AP - WHCB Office and Support Services Renovation ADDENDUM # 1 3/15/2024

## ADDENDUM NO. 1 University of Kentucky Asset Preservation – Renovations for Office & Support Services for White Hall Classroom Building Enabling Project

UK project No. 2590.27 SCB project No. 2364

The purpose of this Addendum is to clarify further the requirements of the plans and specifications. The bidders are governed by the information in this Addendum as if included in the plans and specifications. This Addendum does hereby become a part of the Contract Documents. Each bidder shall acknowledge receipt of this Addendum in the space provided in the Bid Form.

A0.0

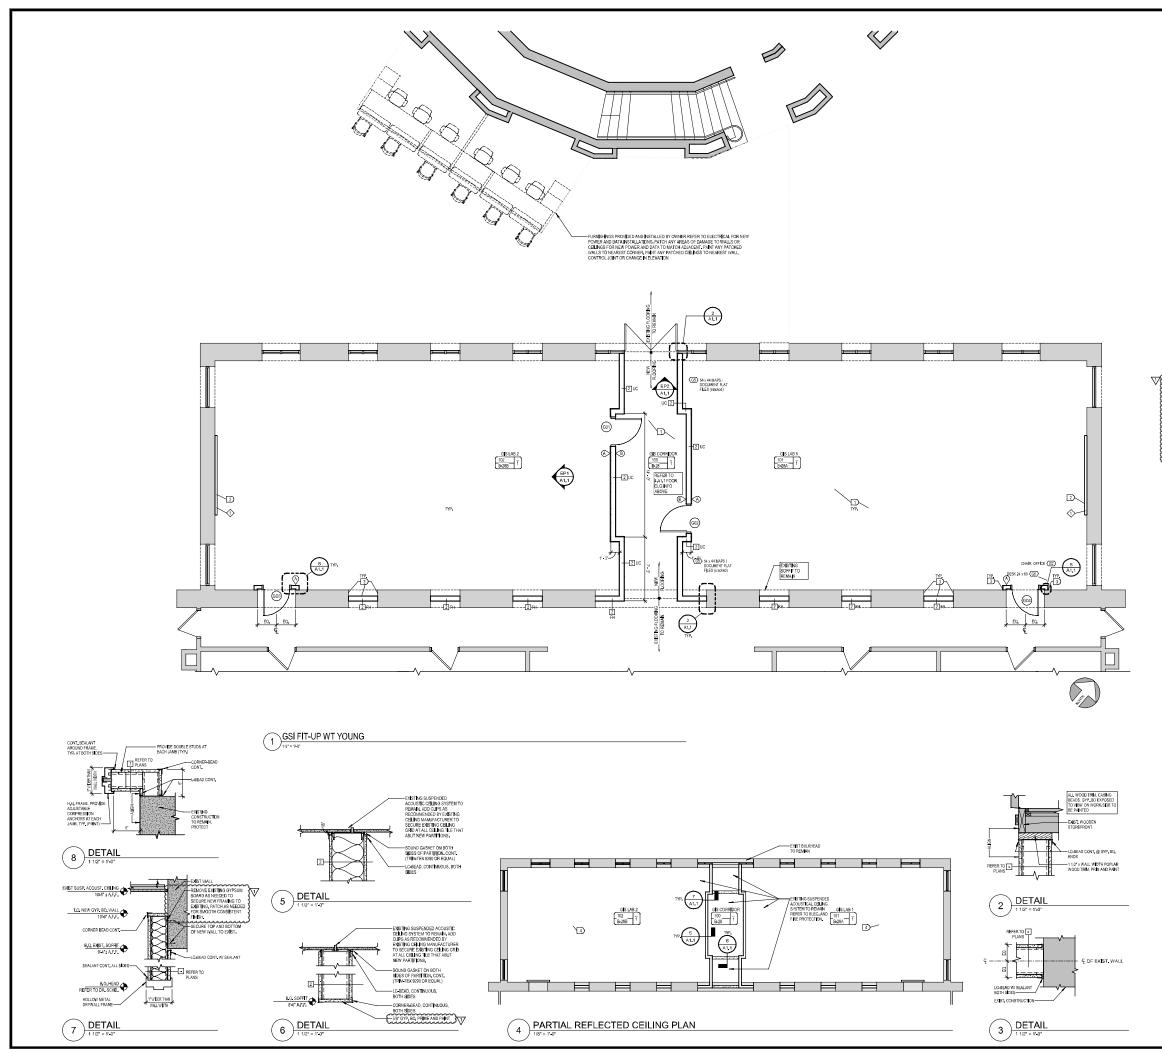
6. Question: "All architectural pages. Are existing walls to be painted or just new partitions?"

7. Question: "On Page A1.2, the wall surrounding the unoccupied area with the deli counter is listed as a type 4 wall which only has gypsum on one side. Do these walls only have 1 side of gypsum/painting? Please confirm."

8. <u>Question</u>: "Please confirm all flooring and wall base for the entirety of the project are demo'd, furnished, and installed by the owner (UK)."

Response: Refer to Room Finish Groups on sheet A0.0.

Response: Partition type-4 (sheet A0.0) has 5/8" gypsum board on both sides metal stud framing. Fully tape / mud / clean / prime / paint side of partition adjacent to renovation. Opposite (unoccupied area) to be taped / mud / clean only (not primed / painted).

Response: Refer to response to item 3 above for GIS spaces. Refer to Room Finish Groups on sheet A0.0 for other spaces.

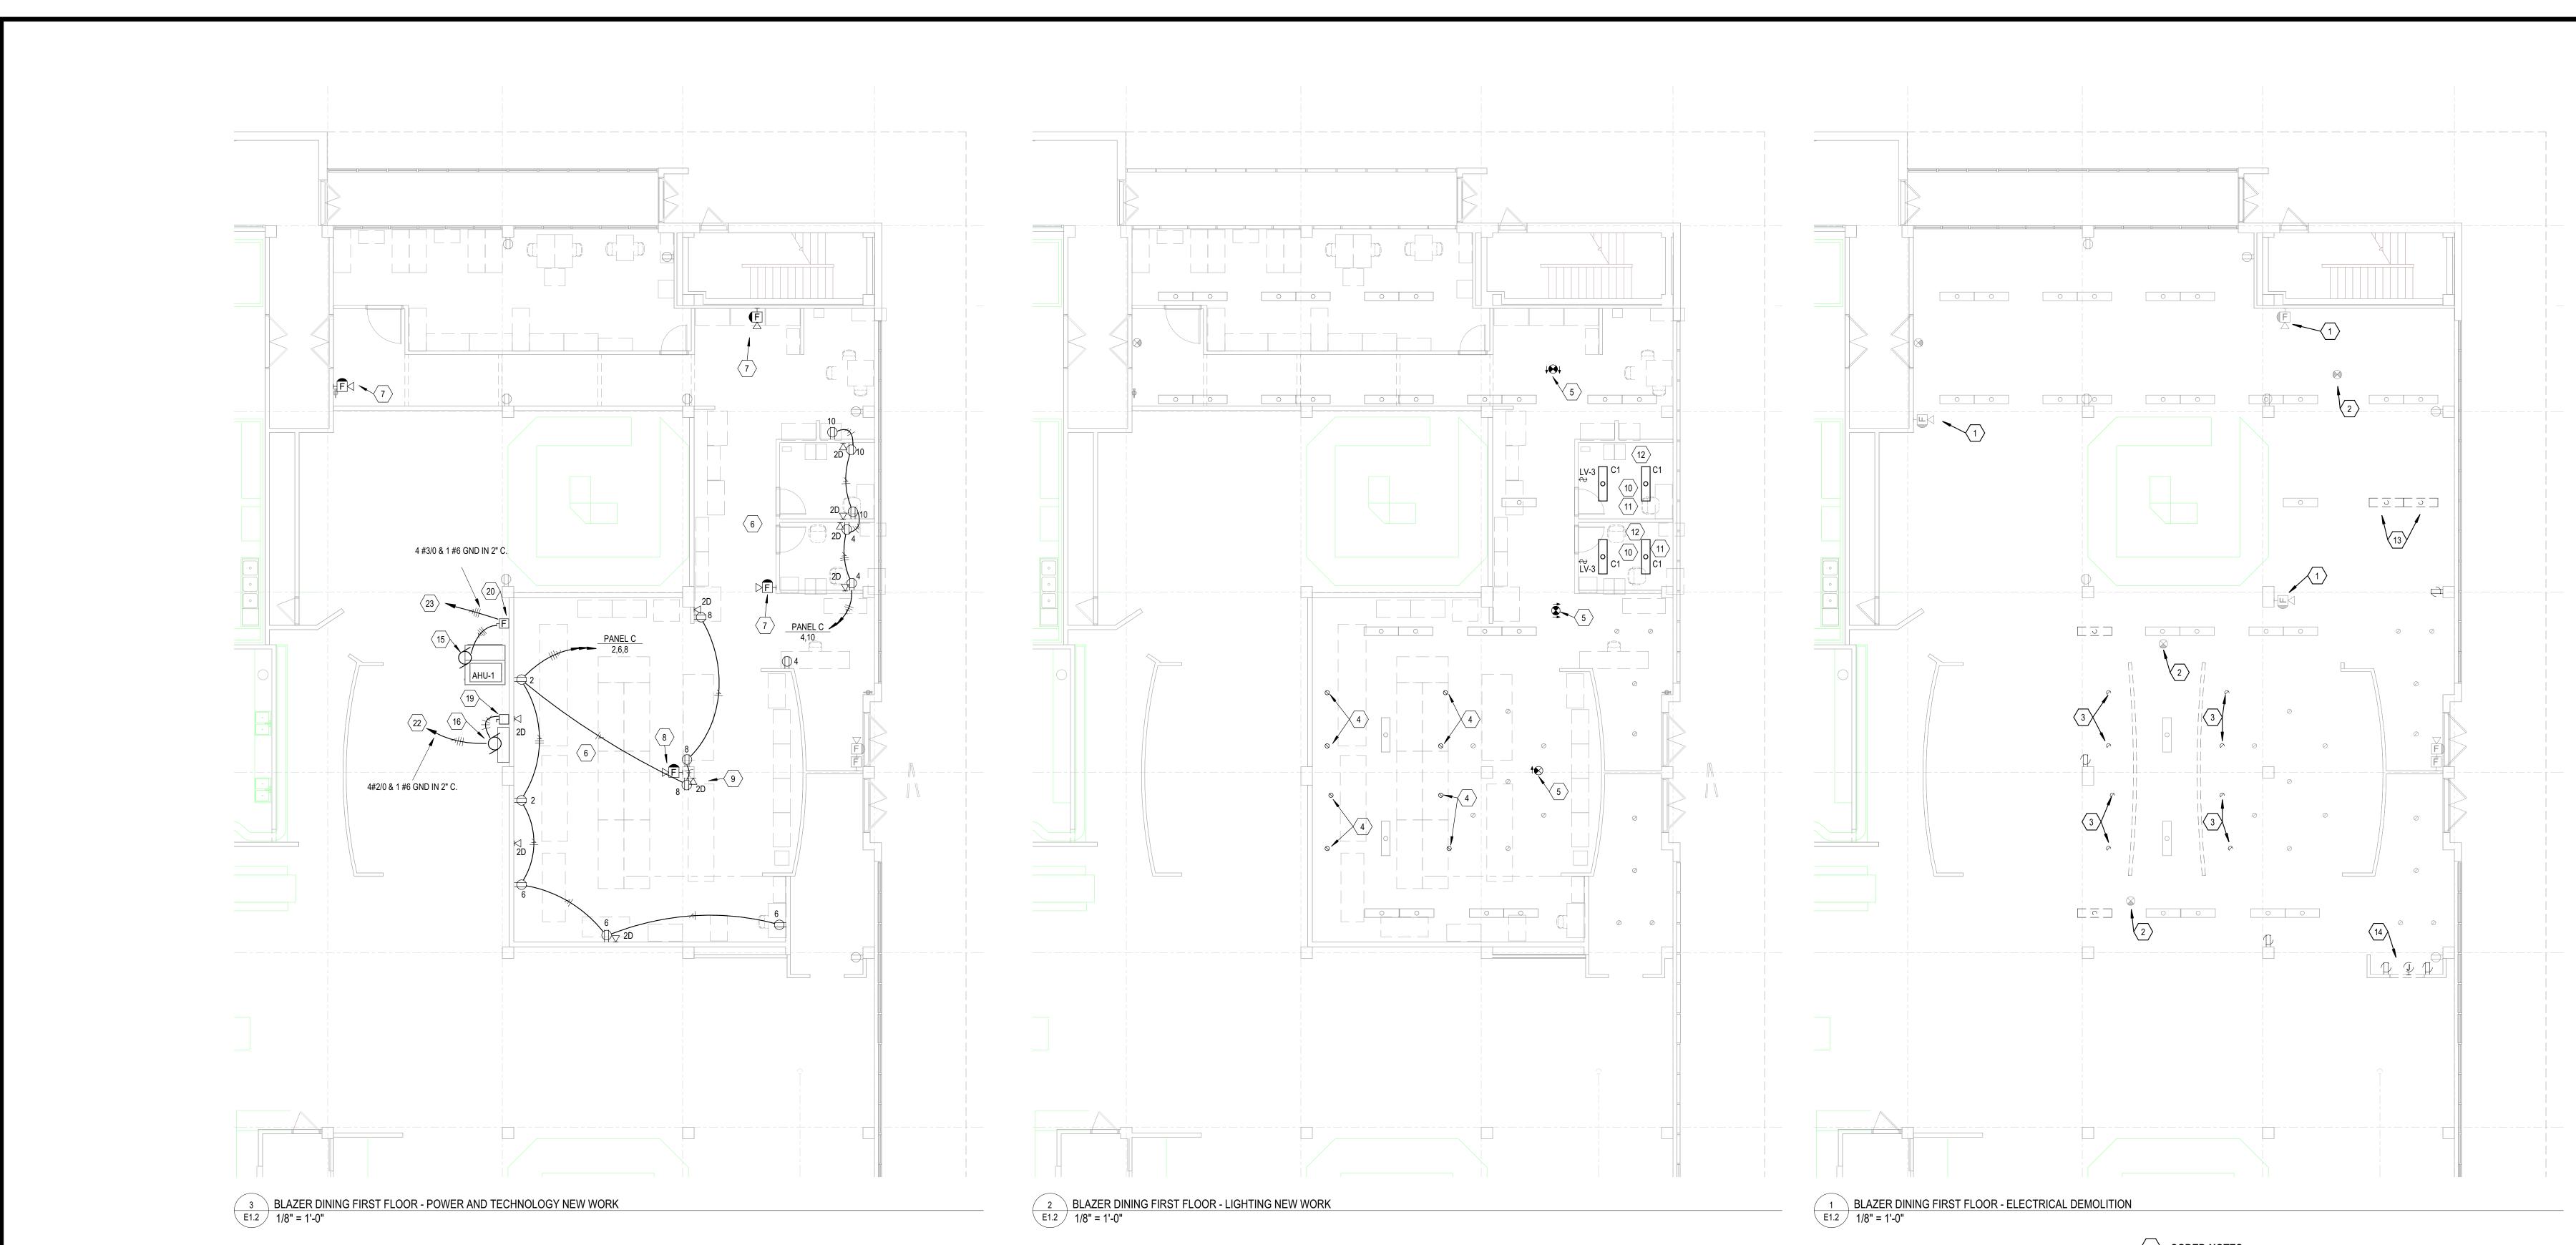
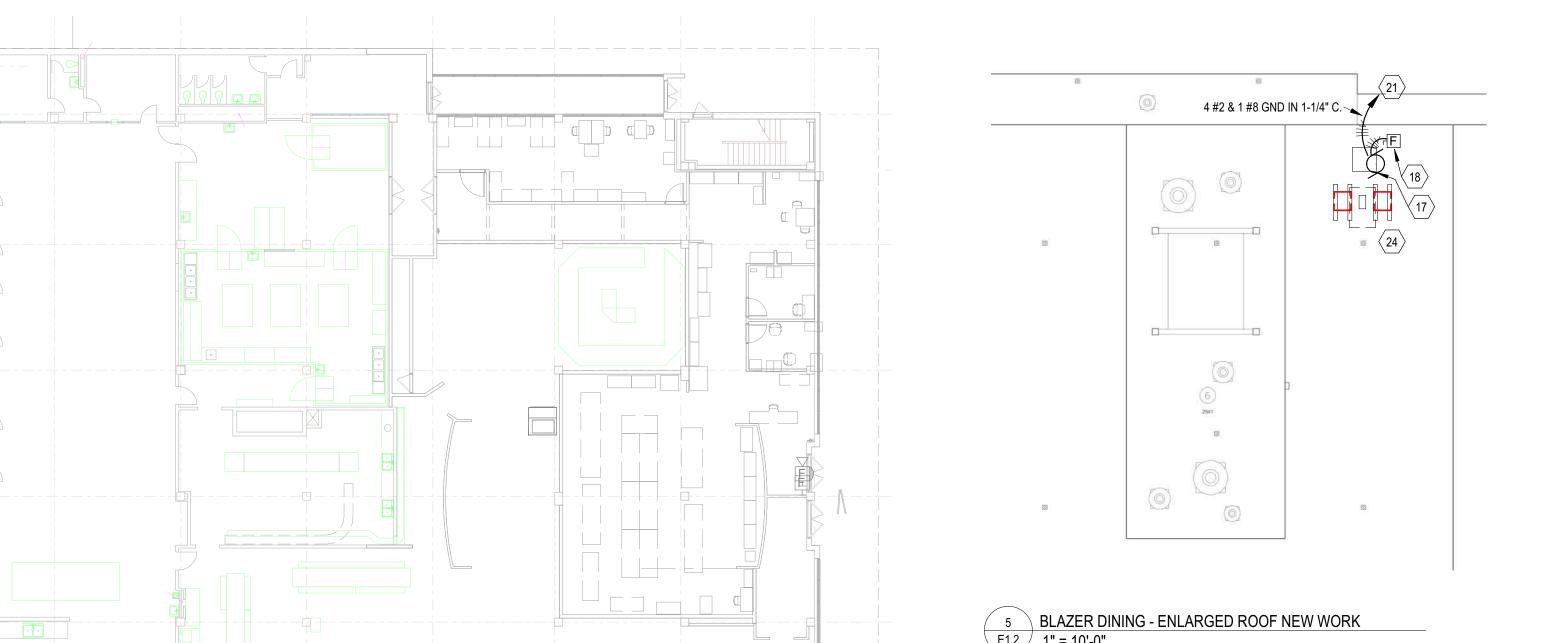
- 1 FIRE ALARM DEVICE IS TO BE RELOCATED. INSTALL BLANK COVER PLATE ON BOX AFTER DEVICE IS REMOVED. SEE NEW WORK PLANS.
- 2 EXISTING EXIT SIGN IS TO BE REMOVED AND REUSED. EXTEND CIRTCUIT AS REQUIRED. SEE NEW WORK PLANS.

- 3 EXISITNG LIGHT FIXTURE IS TO BE DEMOLISHED AND REMOVED. CIRCUITING IS TO REMAIN AND BE REUSED.
- 4 LIGHT FIXTURE IS TO BE INSTALLED IN EXISTING GRID CEILING. CONNECT TO EXISTING CIRCUIT. SEE NOTE 3 THIS SHEET. LIGHT FIXTURE IS TO BE LITHONIA LDN6 40/10 LO6 AR LSS MVOLT OR EQUAL.

- 5 EXISTING EXIT SIGN IS TO BE RELOCATED TO THIS LOCATION. EXTEND CIRCUITING AS REQUIRED.
- 6 ALL NEW RECEPTACLE CIRCUITS SHALL BE FED FROM OVER HEAD AND DOWN NEW WALLS.
  7 RELOCATED FIRE ALARM DEVICE, EXTEND CIRCUITING AS REQUIRED. SEE DEMO PLANS.

- 15 PROVIDE ELECTRICAL CONNECTION TO AHU-1. COORDINATE WITH MECHANICAL CONTRACTOR.
- 16 PROVIDE ELECTRICAL CONNECTION TO ESH-1. COORDINATE WITH MECHANICAL CONTRACTOR.

- 17 PROVIDE ELECTRICAL CONNECTION TO CU-1. CU-1 IS LOCATED ON ROOF. COORDINATE WITH MECHANICAL CONTRACTOR. SEE MECHANICAL PLANS FOR LOCATION.
- PROVIDE AND INSTALL 100A/208V/3P NEMA 3R DISCONNECT FUSED AT 90A FOR CU-1 UNIT. FUSE IN ACCORDANCE WITH MANUFACTURERS INSTRUCTIONS. DISCONNECT IS TO BE MOUNTED ON STRUCTURE. IF BUILDING STRUCTURE IS NOT WITHIN 5 FEET OF MECHANICAL UNIT, PROVIDE UNISTRUT FRAMING TO MOUNT

# 3 BLAZER DINING FIRST FLOOR - HVAC NEW WORK

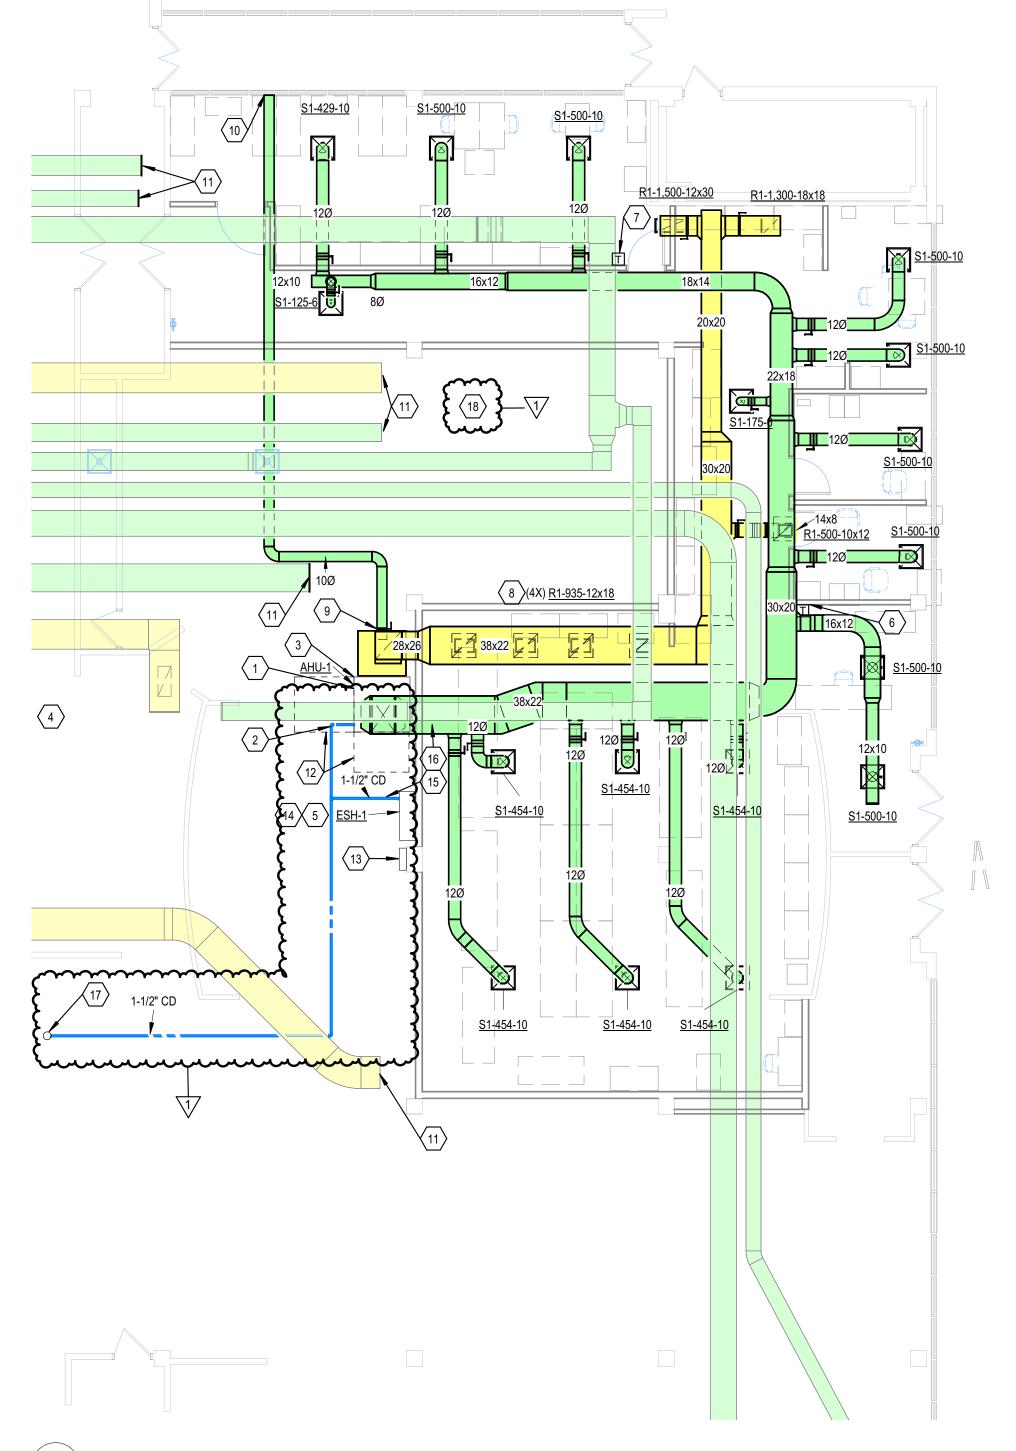
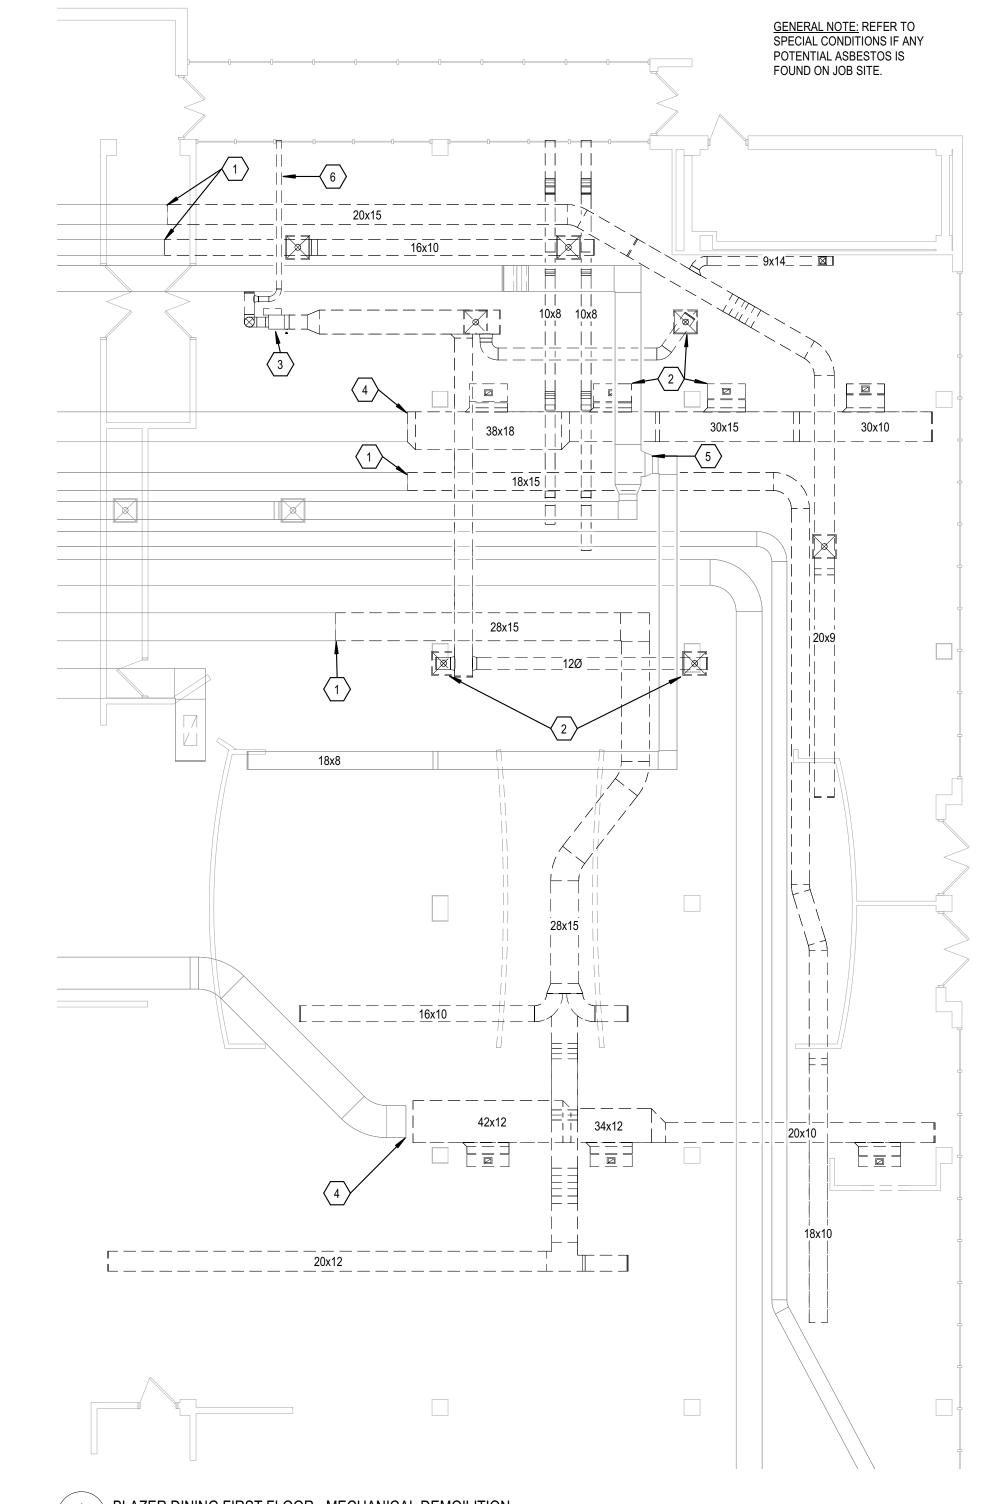
- 6 PROVIDE MASTER THERMOSTAT AND HUMIDISTAT IN THIS APPROXIMATE LOCATION.
- 7 CONTRACTOR TO PROVIDE MONITORING THERMOSTAT AND HUMIDISTAT IN THIS APPROXIMATE LOCATION. TONER ROOM MAY HAVE DAMPERS ADJUSTED AS NEEDED TO

- 8 PROVIDE BALANCING DAMPER FOR EACH RETURN TAP OFF OF MAIN DUCT.
- 9 OA TO BE BALANCED TO 275 CFM.
- 10 CONNECT NEW DUCT TO EXISTING OA LOUVER.
- 11 EXISTING DUCTWORK TO REMAIN OPEN AFTER DEMOLISHED BACK TO THIS POINT.

- 13 INDOOR AHU CONTROL PANEL TO BE MOUNTED TO WALL IN APPROXIMATE LOCATION.
- 14 PROVIDE 3/4" DOMESTIC WATER LINE TO STEAM HUMIDIFIER. RUN FROM NEAREST DOMESTIC FEED IN EXISTING CAFETERIA/KITCHEN.
- 16 DUCT HUMIDIFIER TO BE INSTALLED PER MANUFACTURER INSTRUCTIONS AND RECOMMENDATIONS IN THIS APPROXIMATE LOCATION.
- 17 ROUTE CONDENSATE LINE TO EXISTING FLOOR DRAIN IN THIS APPROXIMATE LOCATION.

1 BLAZER DINING SECOND FLOOR ROOF PLAN - ENLARGED SCOPE OF WORK AREA NOT TO SCALE

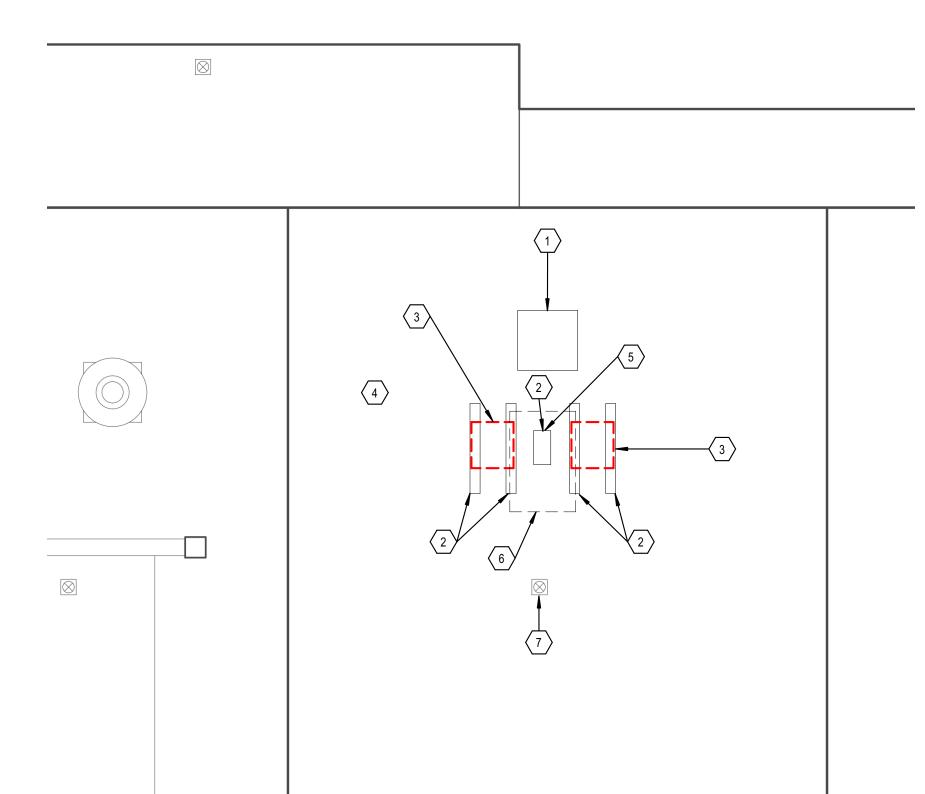
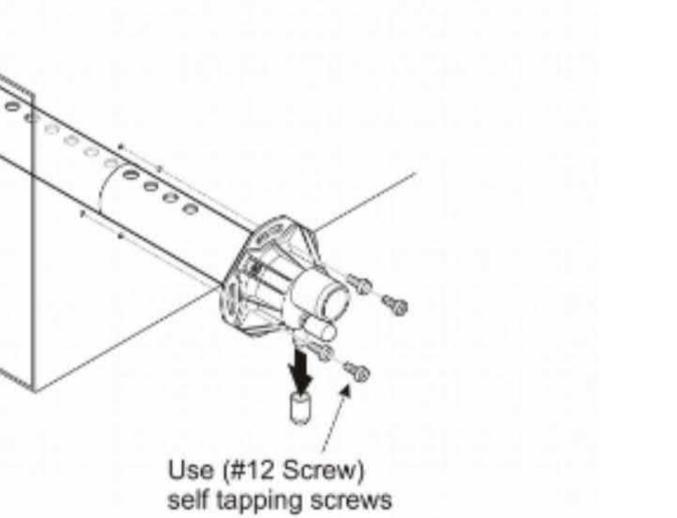
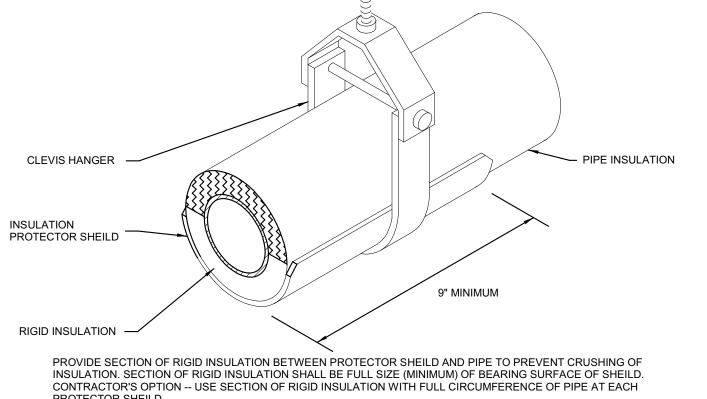
5 NEW ELECTRICAL CONNECTIONS AND MECHANICAL REFRIGERATION LINES TO RUN UNDERNEATH NEW CONDENSING UNIT AND ROUTE THROUGH THE EXISTING ROOF CAP/PENETRATION. PROVIDE NEW CAP AND SEALING ON TOP OF ROOF PENETRATION.

6 FOOTPRINT OF NEW CONDENSING UNIT. REFER TO STRUCTURAL DETAIL FOR MOUNTING DETAILS TO EXISTING RAILS AND NEW STRUCTURAL SUPPORT.
